INDIANA DEPARTMENT OF TRANSPORTATION

APPROVED MINUTES

April 16, 2026, Standards Committee Meeting

RE: Minutes from the April 16, 2026, Standards Committee Meeting

E 801-TCLC-02 Long-Term Stationary Freeway Right Lane Closure (shown markups)

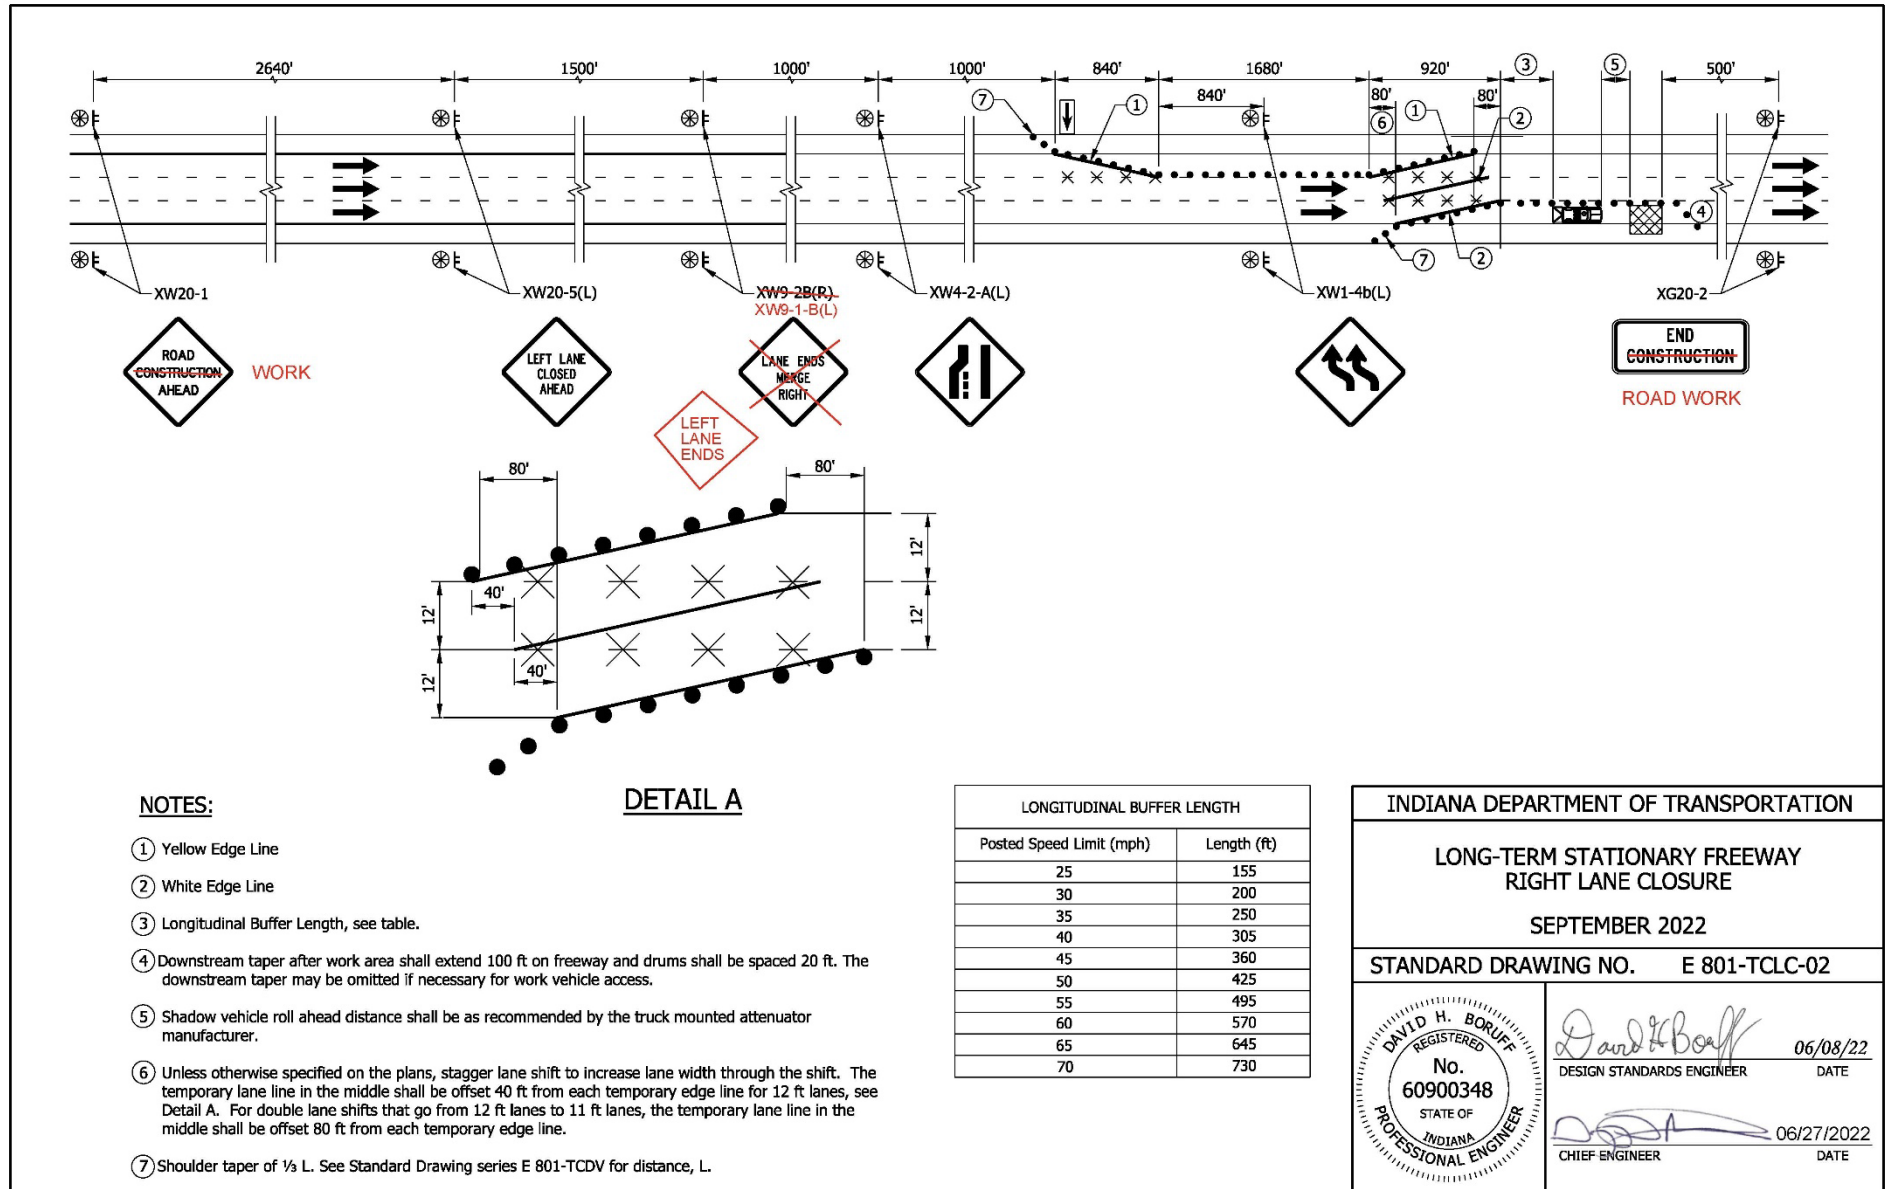
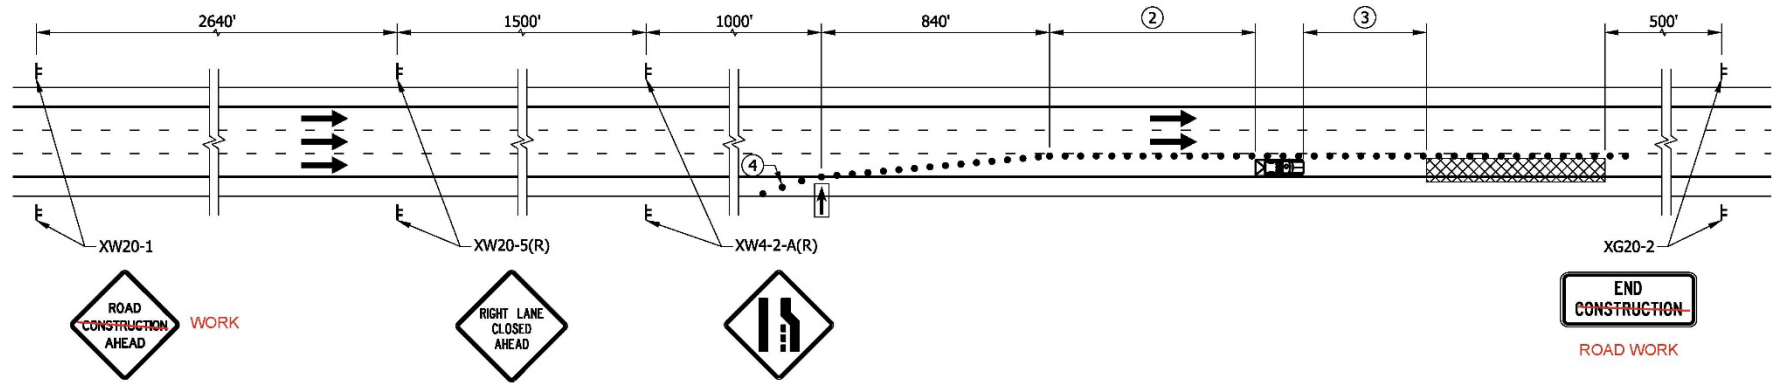
PROPOSED SOLUTION: Update these Standard Drawing series for the current edition of the MUTCD.

E 802-SNDH-02 Sign Placement Divided Highway Intersection (shown markups)

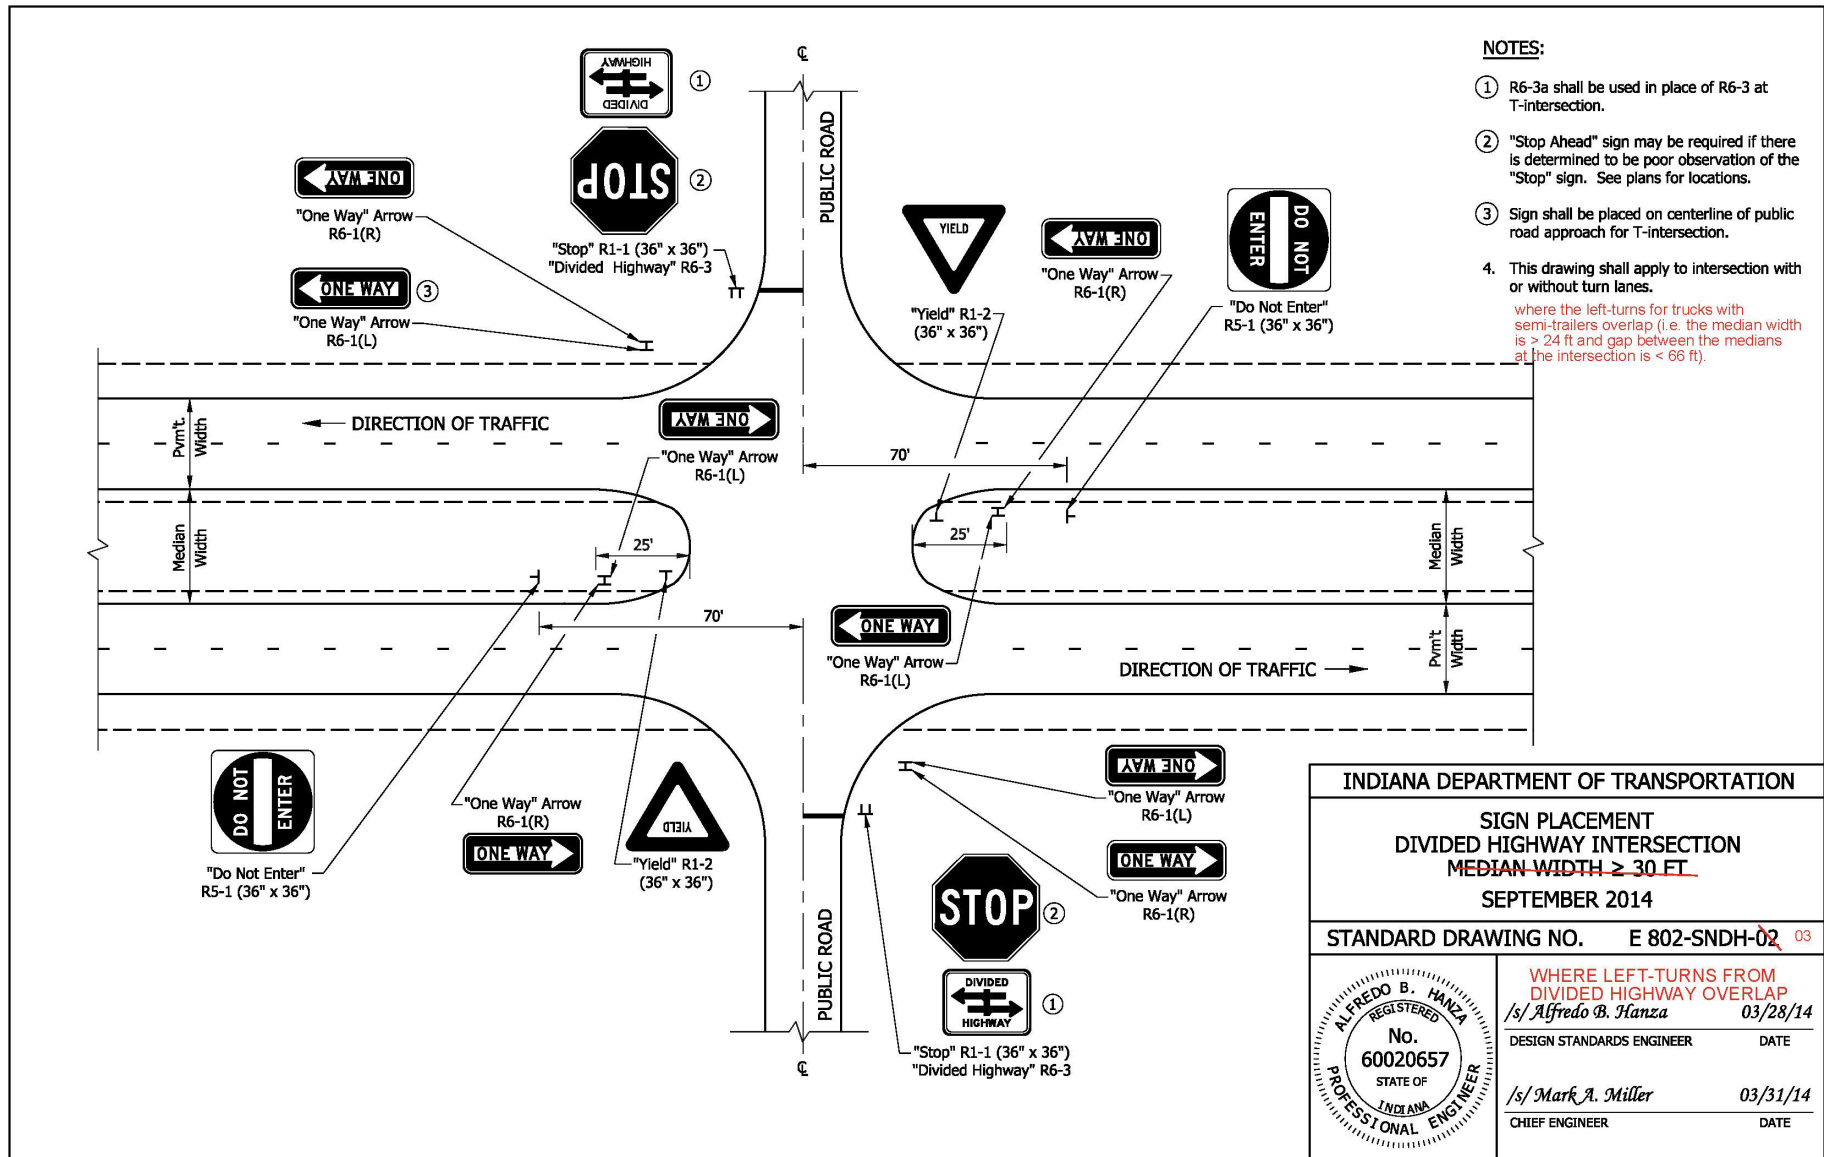
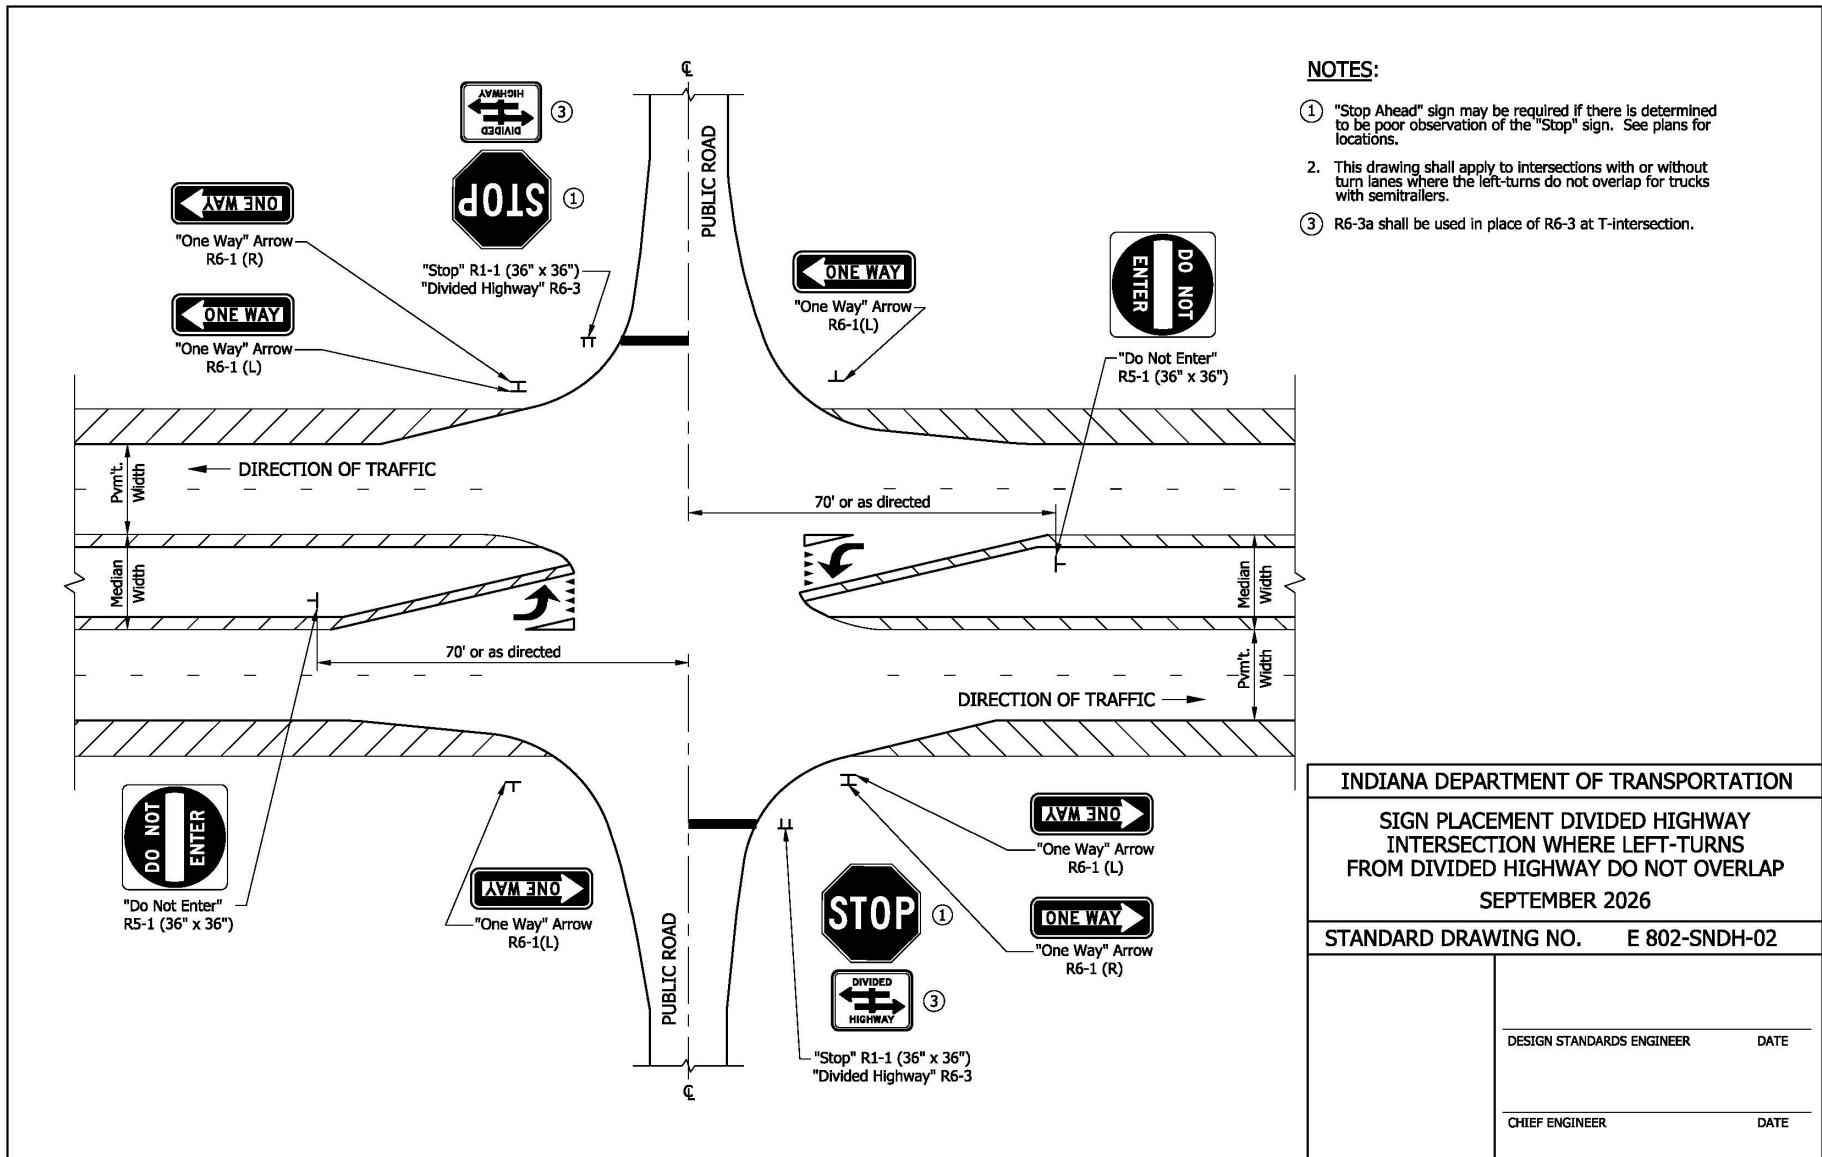
PROBLEM(S) ENCOUNTERED: Section 1B.02 of the 11th edition of the MUTCD requires states to update standard drawings to be in substantial conformance with the MUTCD. The 802-SNDH, 802-SNPL, and 802-SNGS Standard Drawing series need various minor updates for the current edition of the MUTCD.

PROPOSED SOLUTION: Update these Standard Drawing series for the current edition of the MUTCD.

E 808-DLIM-02 Dotted Lines for Freeway Acceleration Lanes (shown markups)

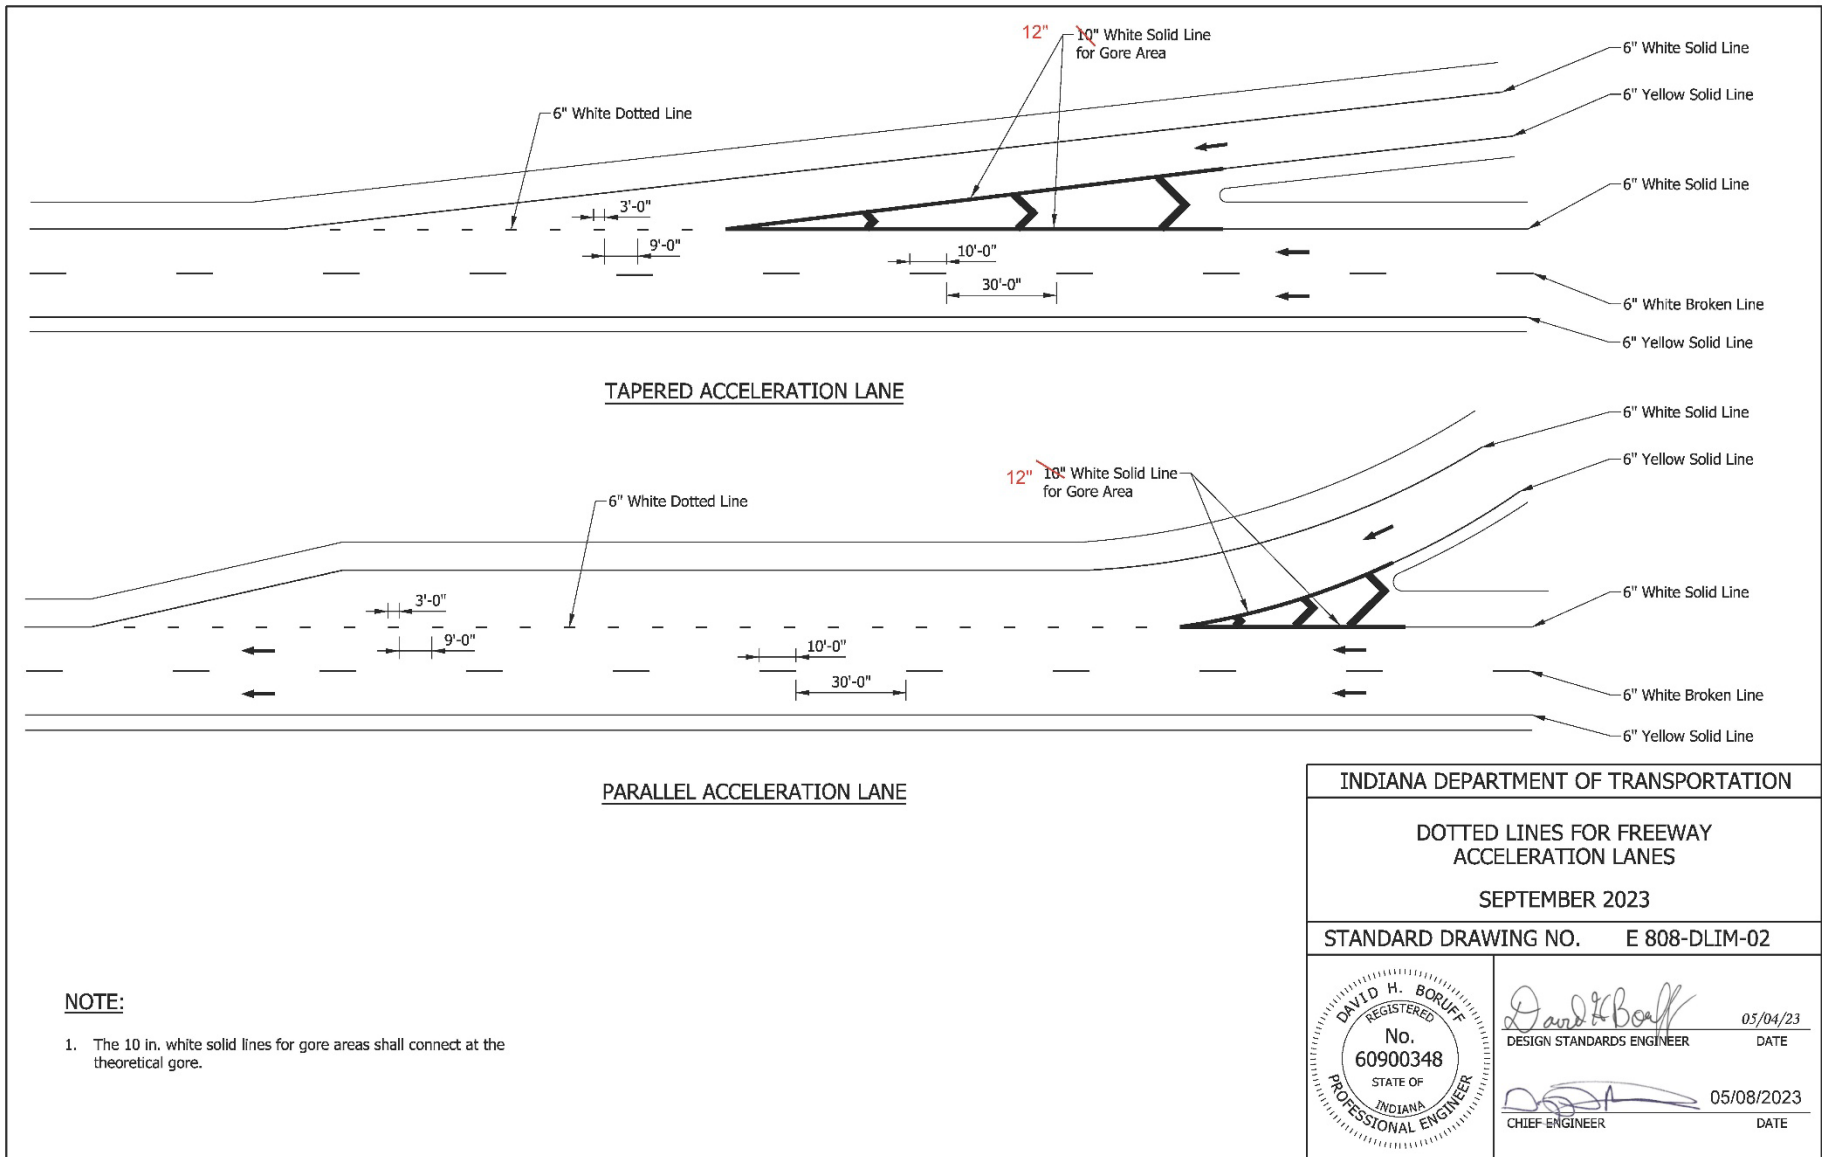
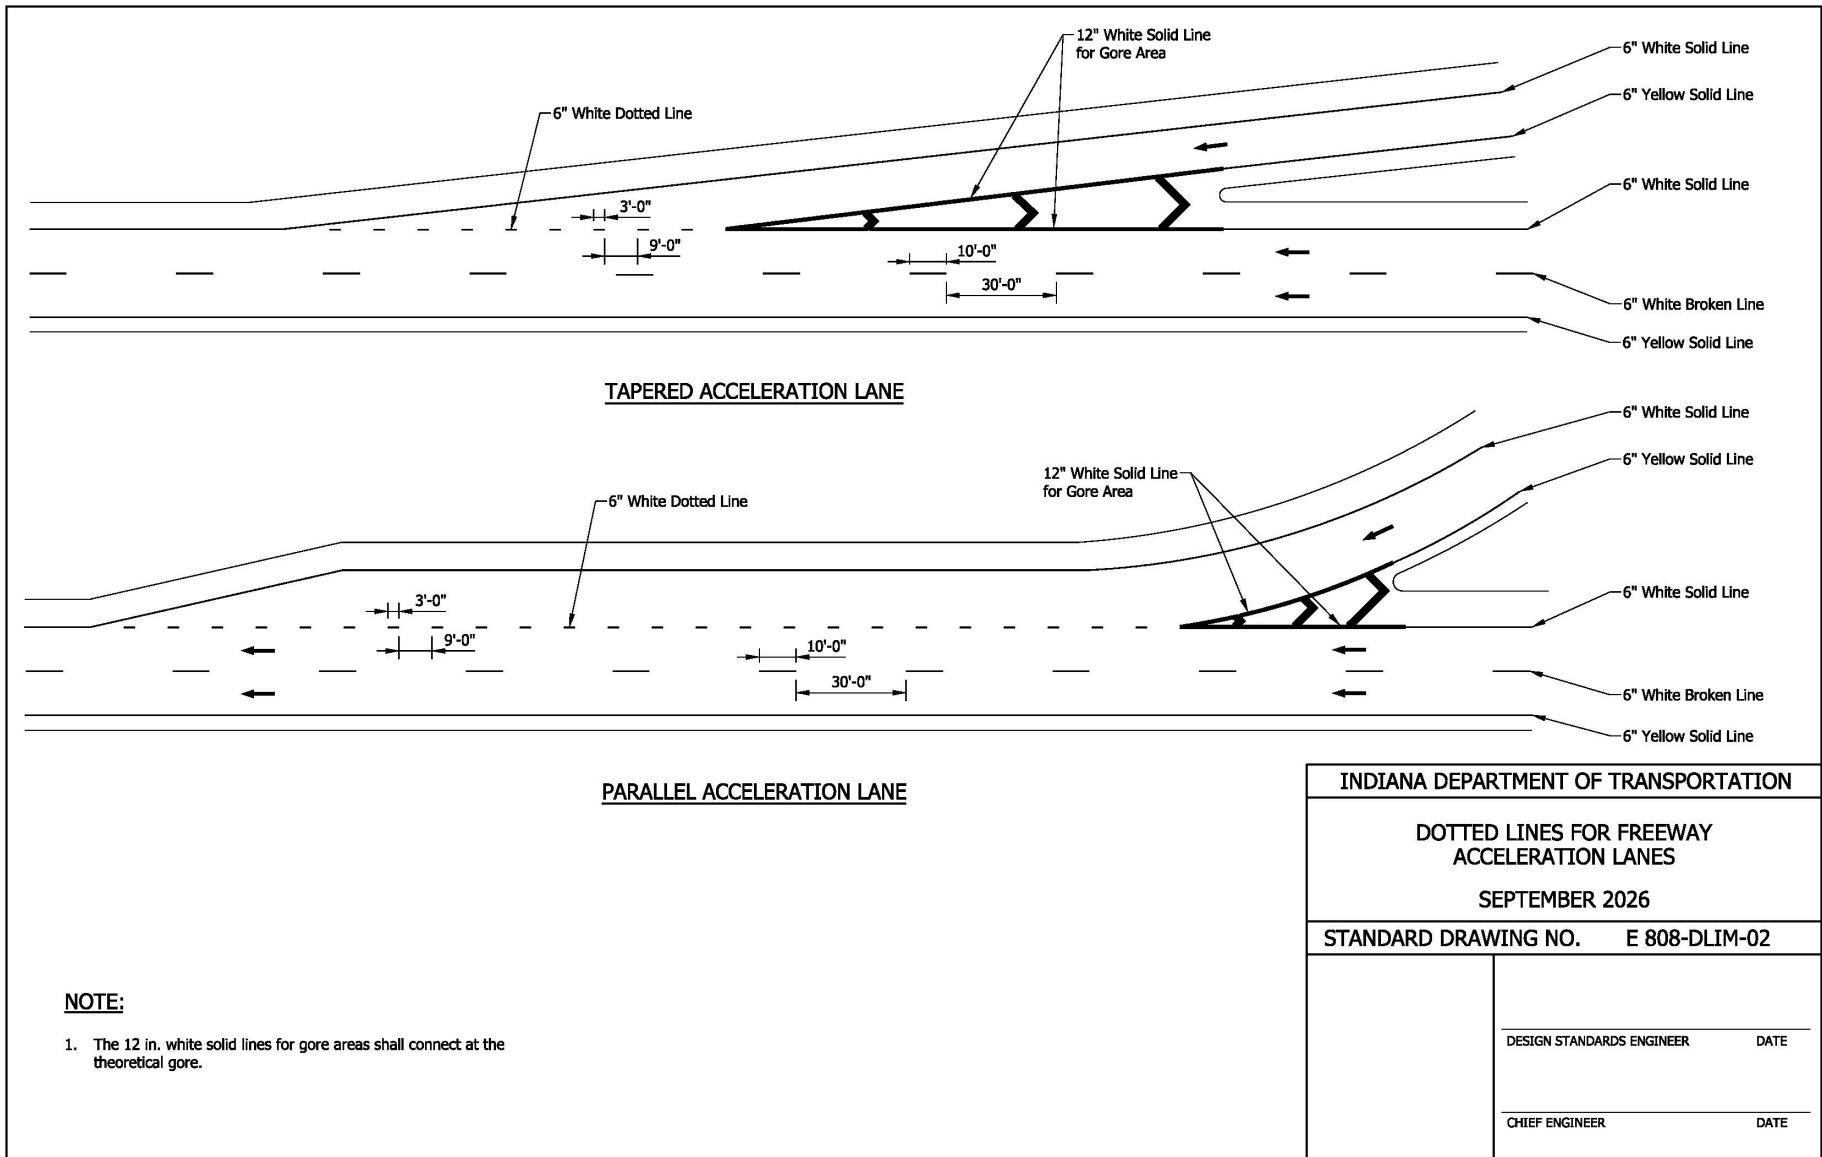
PROBLEM(S) ENCOUNTERED: Section 1B.02 of the 11th edition of the MUTCD requires states to update standard drawings to be in substantial conformance with the MUTCD. The 808-DLIM Standard Drawing series need various minor updates for the current edition of the MUTCD and the table in Standard Drawing 808-MKPM-06 needs to be updated for the current edition of the MUTCD.
